SKEP III Home Office Support Site Visit Report

Consultant	Wahib Medanat Consultant Engineer	Rep No.	21-06122021
Contractor	Dijlah Establishment Constr. Contracting	Tender No.	(11/2019/USAID/SKEP/3/S) Schools for a Knowledge Economy Project (SKEP) - Phase (3) Package (1, 2)
Site Name	Hay Al Iskan Basic Mixed School- Jerash	Day/ Date	Mon. 06/12/2021
Duration of Project	450 Calendar Days	Total Project Budget	8,314,983.735 JD

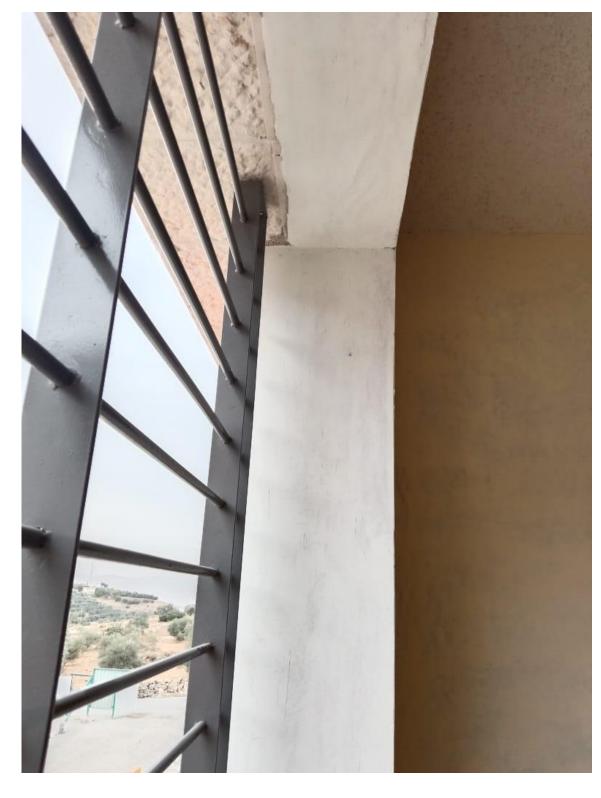
Teething was observed in the granite tiling of staircases' landing. The Contractor was instructed was instructed to rectify
